SUBJECT: Job# 100984, Dineen Hall, Bulletins 190 & 192 RFP

Addendum #1

Project No. 100984

Automatic Door Operators & Mechanical Access Platform

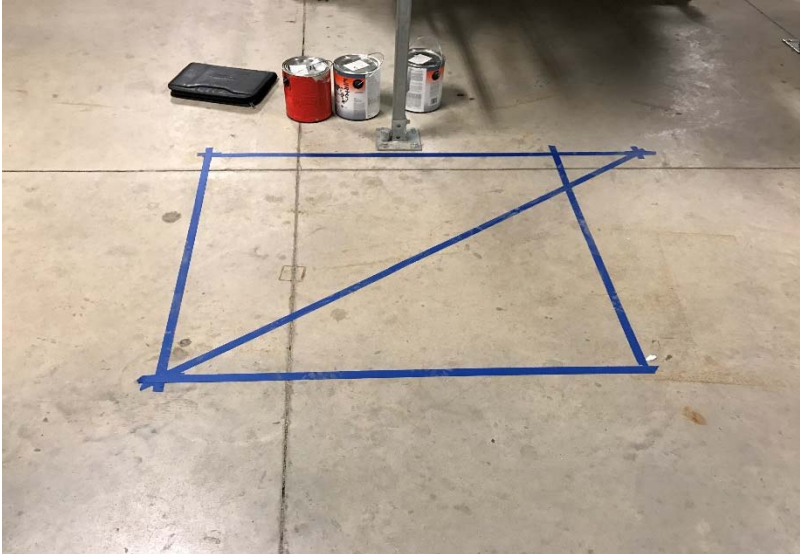
2. Doors 295V, 395V and 495V, wood doors can be reused in the area where the existing closer was mounted patched to match
3. Bulletin 192, plan sheet S101 the mechanical platform at Exhaust Fan EF-6 is to be a part of the work for this bulletin. The photograph included in the Bulletin relates to the platform at fan EF-7 but there is a second platform required for fan EF-6. This will be a (3) post base with a square deck cantilevered out toward EF-6.

The picture below relates to where this will be positioned and was placed with a laser level. It appears that there is space available for the post to be positioned between existing conduits and that no conduit relocation should be necessary.

4. No access ladder will be required for the platform at EF-6.
5. From Bulletin 192, plan sheet S101, the required finish for the platform railings should be factory prime painted to match adjacent miscellaneous metals. Gratings shall be factory galvanized.

SKE
192.1

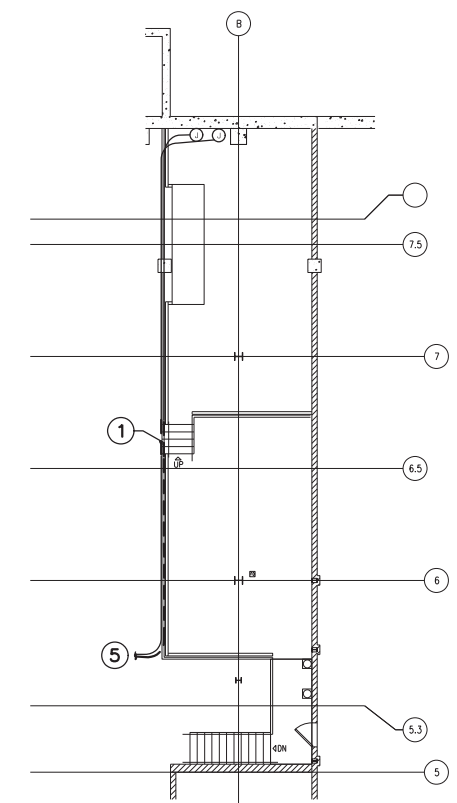
7. Bulletin 192, plan sheet S101, steel mechanical repair access platform at Exhaust Fan EF7. While visiting the site we reviewed the location of this platform and are concerned that some mechanical and or electrical systems will need to be relocated to install this platform. There is no mechanical or electrical relocations indicated to install this platform. Please clarify.
No mechanical relocations are anticipated. There are electrical relocations anticipated and they are indicated on drawing SKE 192.1, note number 1. A copy of this drawing is attached to this addendum.

- 1 TOTAL OF THREE (3)-1" CONDUITS MOUNTED TO STAIR RAILING SHALL BE RELOCATED TO WALL BELOW STAIRS.
- 2 ONE CONDUIT TERMINATES AT THE CABLE TRAY AND INCLUDES A DATA CABLE. REWORK CONDUIT TO THE EXTENT NECESSARY TO PROVIDE REUSE OF EXISTING CABLE.
- 3 TWO CONDUITS TERMINATE IN ELECTRIC ROOM. REWORK CONDUITS AT STAIRS, PROVIDE NEW JUNCTION BOXES AS REQUIRED AND EXTEND CABLES FOR NEW ROUTING.
- 4 CONTINUES ON MEZZANINE FLOOR PLAN (SAME DRAWING)
- 5 CONTINUES ON LEVEL G FLOOR PLAN (SAME DRAWING)

8. For bid purposes contractors should plan for electrical circuits to be relocated shall be on second or third shift.
